STAFF REPORT
COMMUNITY DEVELOPMENT DEPARTMENT

HEARING DATE: 11/1/2022
 TO: Mayor & City Council
 FROM: Joe Dodson, Associate Planner
 208-884-5533
 SUBJECT: H-2022-0050
 Allure Subdivision

B. Preliminary Plat (dated: 6/15/2022)

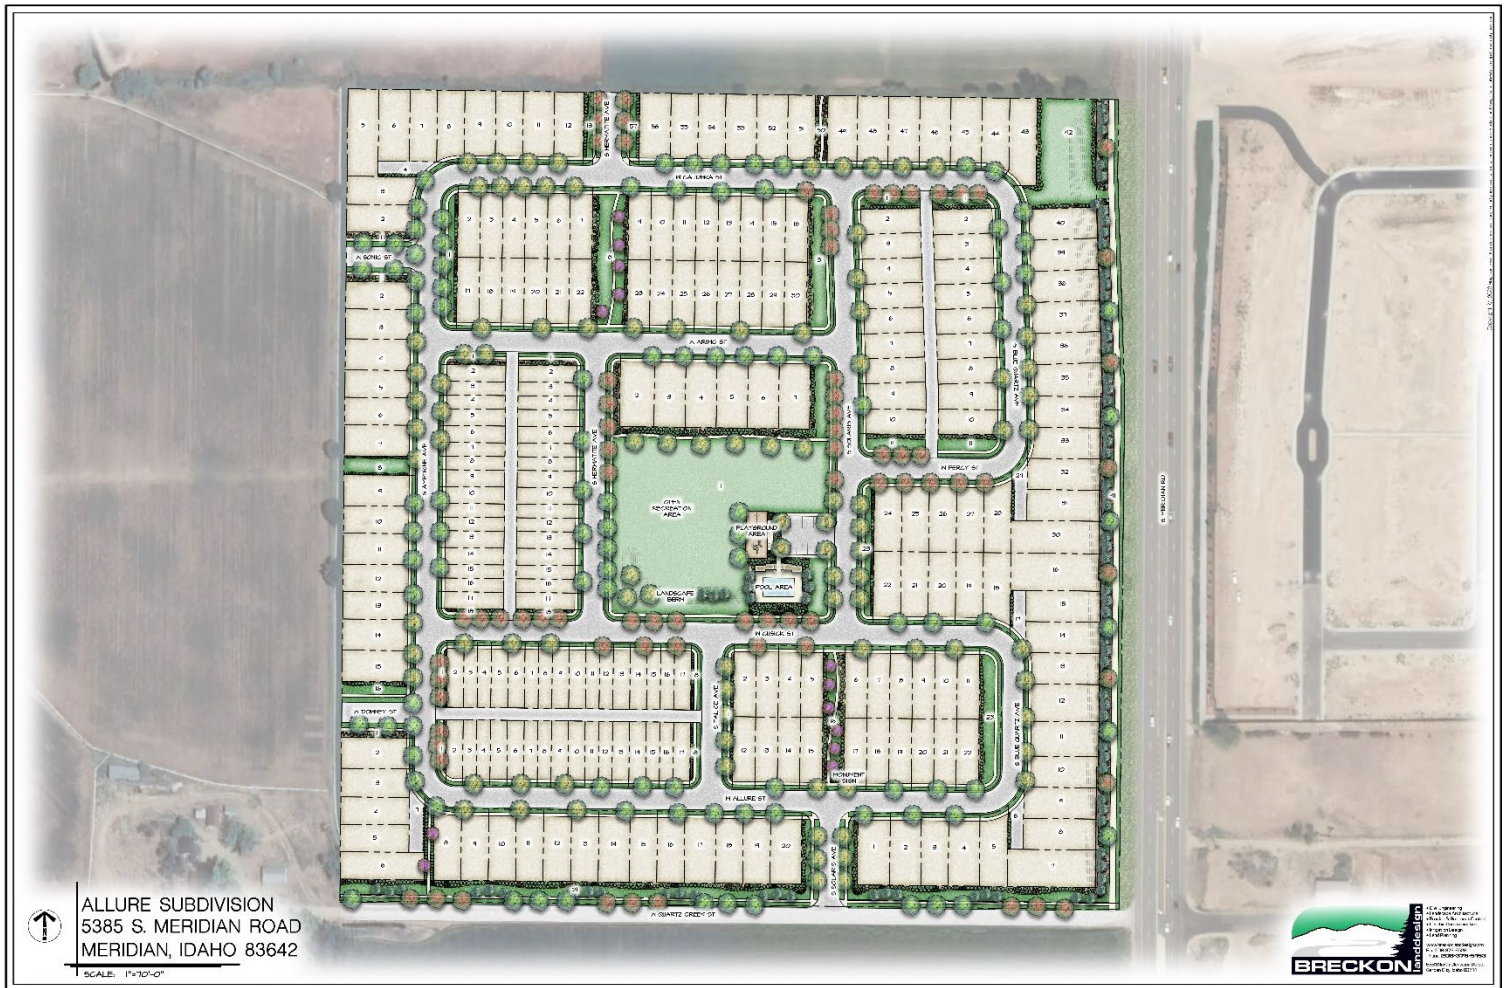
The proposed preliminary plat and submitted plans appear to meet all UDC requirements but the plat should depict the proposed lots that have zero lot-lines (proposed attached and townhome products) to ensure compliance with setback requirements with the future building permit submittals. Therefore, the Applicant should revise the plat to depict the applicable zero lot-lines with each applicable final plat submittal.

2. The preliminary plat included in Section VII.B, dated June 15, 2022, shall be revised as follows with the applicable final plat submittals:
 - a. Revise the plat to show ACHD approved traffic calming along W. Quartz Creek Street, S. Ametrine Avenue, W. Allure Street, W. Cusick Street, S. Solaris Avenue, and W. Caldera Street, coordinate with Meridian Fire and ACHD as necessary.

- b. Depict the required emergency access to Meridian Road/SH 69, as approved by the Meridian Fire Department.
 - c. With each applicable final plat submittal, revise the plat to depict any proposed zero lot-lines for the single-family attached and single-family townhome dwellings.

- d. Add a plat note stating that direct lot access to S. Meridian Road/SH 69 and W. Quartz Creek Street is prohibited.
3. The landscape plan included in Section VII.C, dated June 15, 2022, shall be revised as follows ~~prior to the City Council hearing~~ with the applicable final plat submittals:

C. Landscape Plans (date: 6/15/2022):

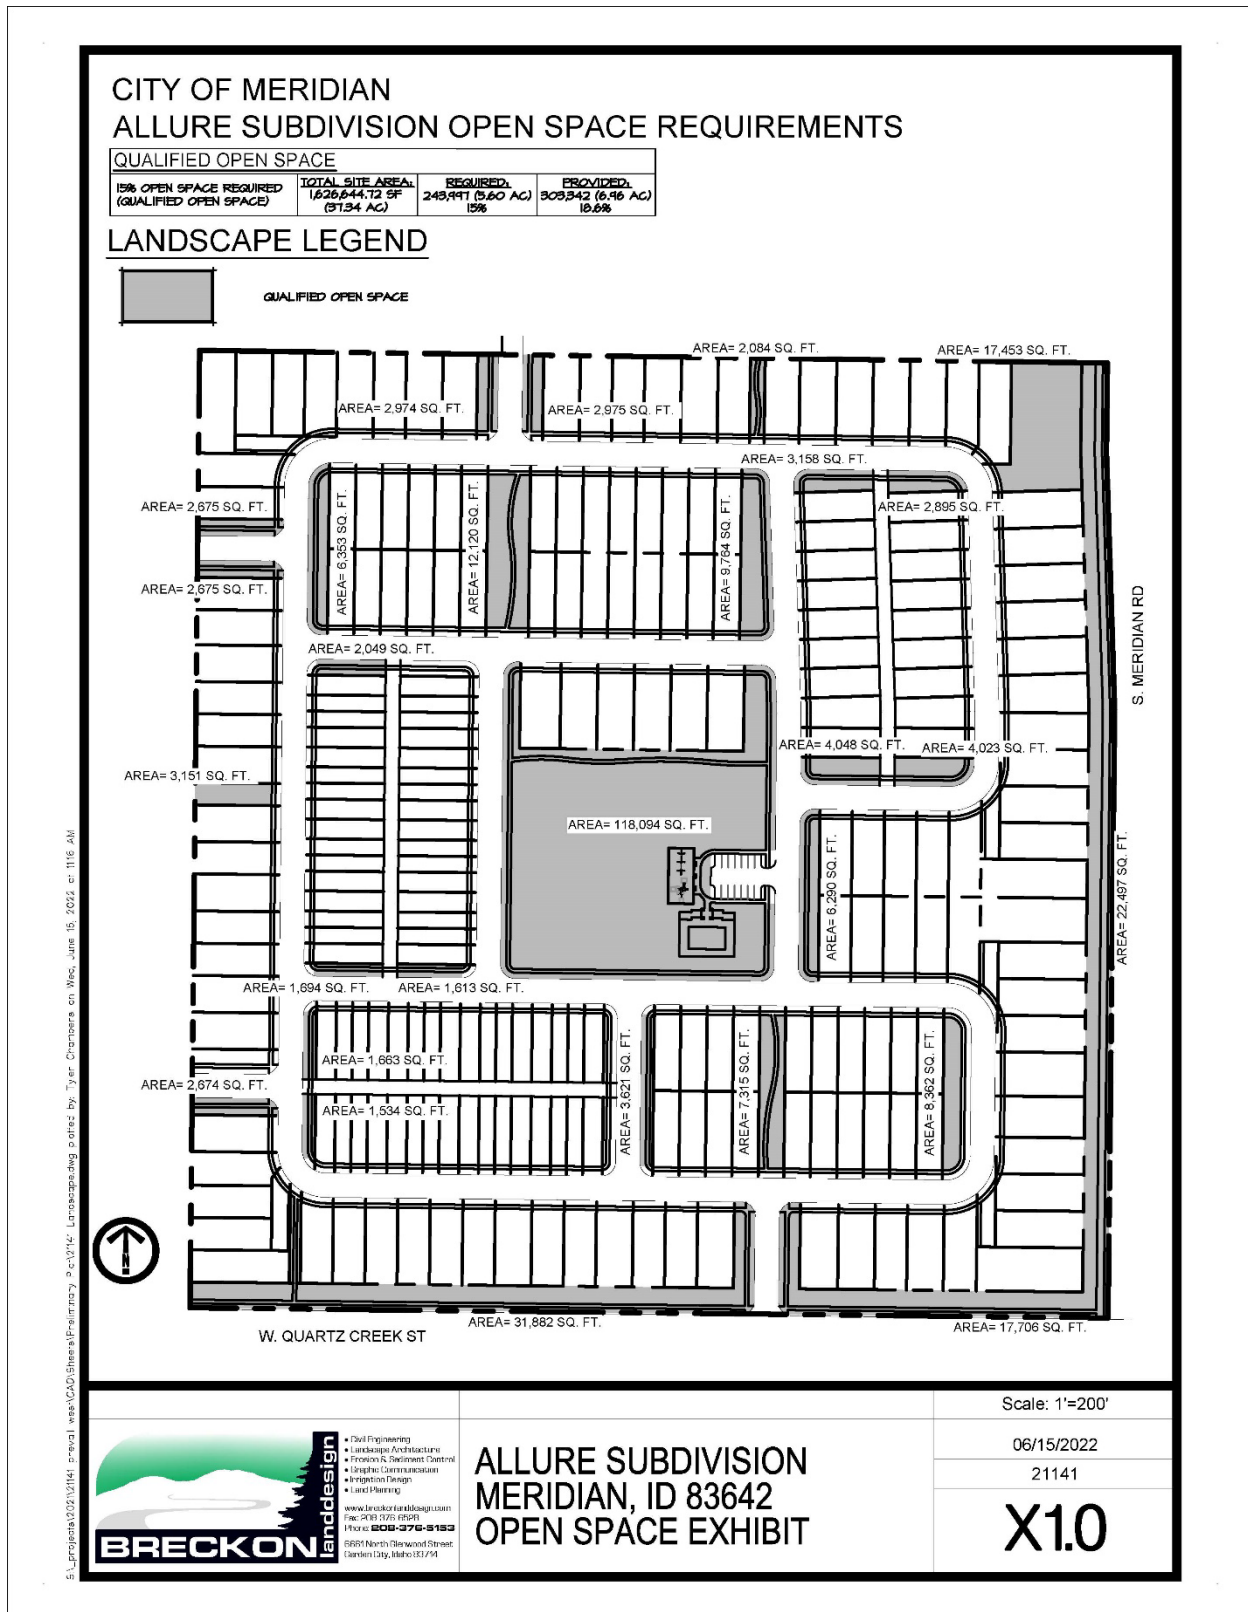
the TN-R zoning district. Parkways are required to be vegetated with an average of 1 tree per every 35 linear feet to be compliant. The submitted landscape plan appears to show compliance with this requirement but the calculations table does not note the linear feet of parkways along the interior local streets and the required number of trees; the Applicant should correct this with the Final Plat submittals to ensure compliance with this requirement.

All fencing is required to comply with the standards listed in UDC 11-3A-7. Fencing is proposed as shown on the landscape plan and appears to meet UDC standards as proposed except for the lack of fencing noted adjacent to the common drives and the 6-foot open vision fencing proposed adjacent to three micro-path lots (Lot 21, Block 2, Lot 16, Block 3, & Lot 8 Block 10).

The submitted landscape plans do not depict any fencing adjacent to the common drives as required by code for properties that do not take access from the common drive. Therefore, with the future final plat applications, the Applicant should revise the landscape plans to depict the proposed fencing on the required common drive exhibit.

- a. Revise the landscape plan to match the plat revision noted in VIII.A2 above.
 - b. Depict the required berm/wall combination along Meridian Road to extend to the north property line to minimize the breaks in the wall.

- c. In the landscape calculations table, show the linear feet of parkways and include the required number of trees and proposed number of trees in accord with UDC 11-3B-7C.

- d. Revise the fencing adjacent to three micro-path lots (Lot 21, Block 2, Lot 16, Block 3, & Lot 8 Block 10) to be 6-foot privacy fencing.
 - e. With the future final plat applications, depict the proposed fencing adjacent to the proposed common drives.

D. Open Space Exhibit (dated: 6/15/2022):

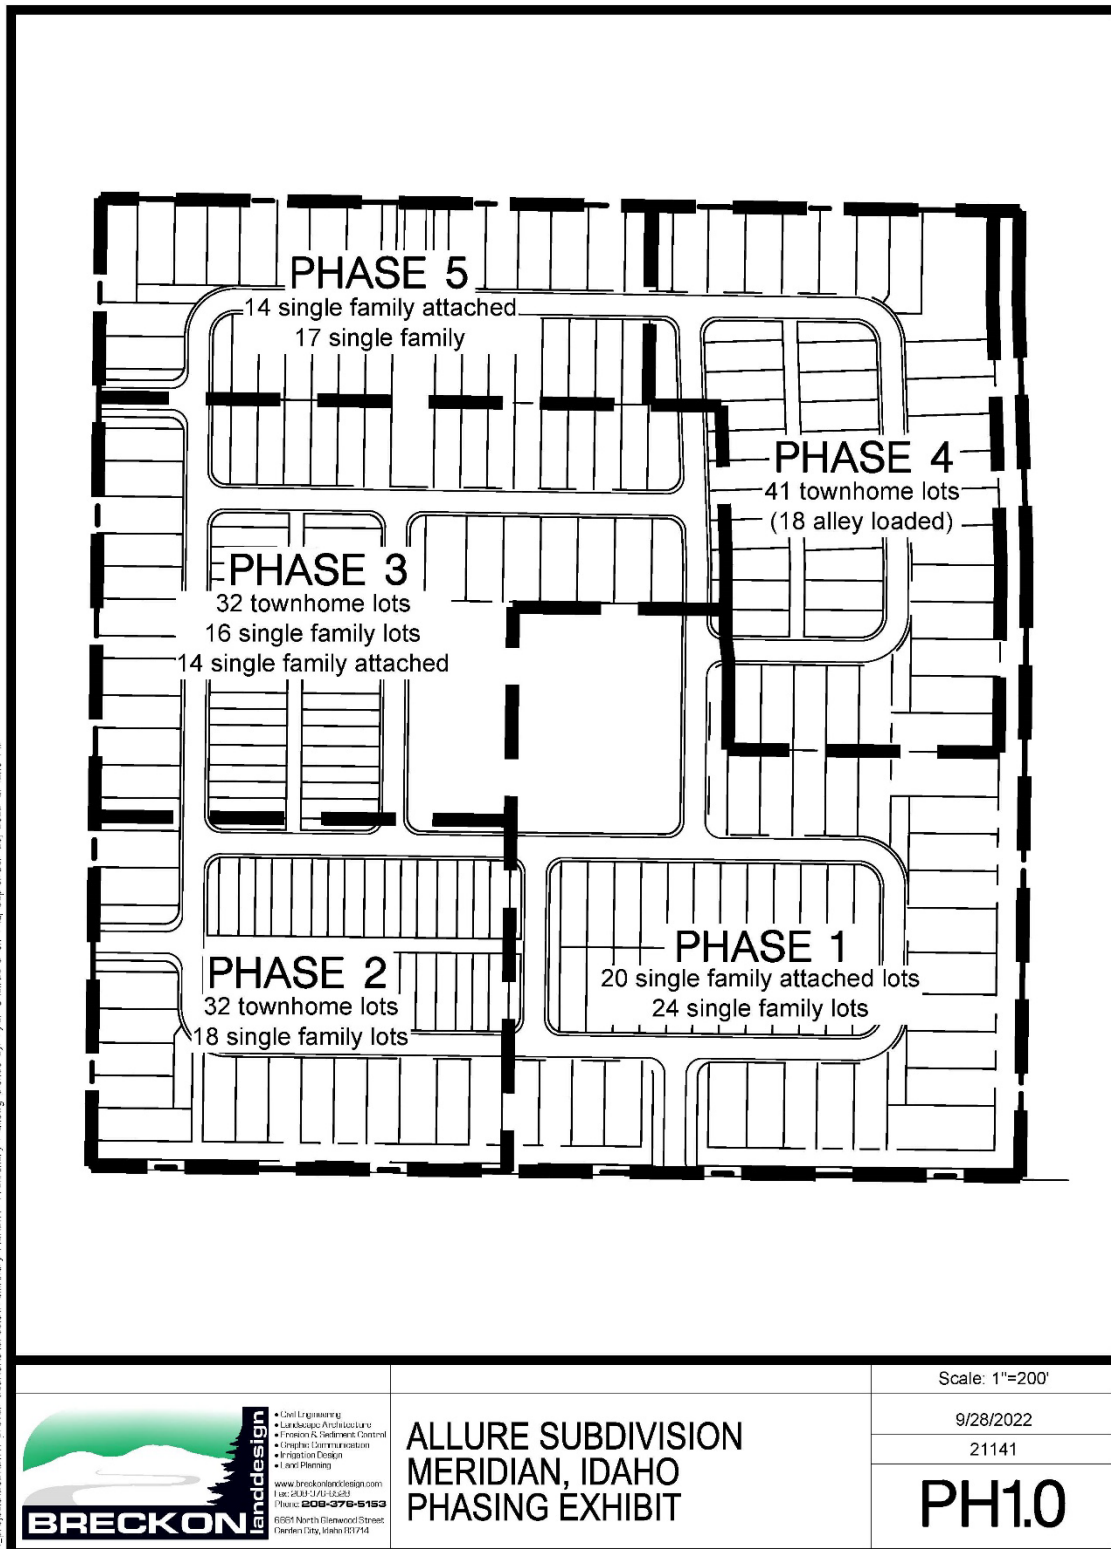
The Applicant's open space exhibit (Section VII.D) shows 6.96 acres of qualified open space (approximately 18.6%), exceeding the minimum required amount of 5.6 acres. However, some of the areas noted on the exhibit as qualifying do not qualify per UDC 11-3G-3 standards because they are not at least 20 feet in width. Staff does not recommend these areas be revised to add an additional few feet as they are already remnant pieces along end-caps of housing blocks that do not entirely meet the intent of the open space code. Further, the removal of these areas is nominal and will not affect the Applicant's compliance with the minimum open space requirements. It is important to note the Applicant's qualified open space calculation does not include any of the parkways within the development which is qualifying open space if the correct number of trees are added to the parkways. Therefore, the actual proposed qualified open space vastly exceeds the minimum amount required by code. The Applicant does not need to use this area as qualified open space to meet the minimum 15% amount and parkways are already required as part of the site design for the requested TN-R zoning district. So, Staff is not concerned the open space exhibit does not show this area but would recommend this area is added to the exhibit to ensure a fully accurate open space calculation is depicted in the record. ***This revision should occur prior***

to the City Council hearing.

- 5. Prior to the City Council hearing, the Applicant shall submit a revised Open Space Exhibit depicting the qualifying parkways throughout the development.**
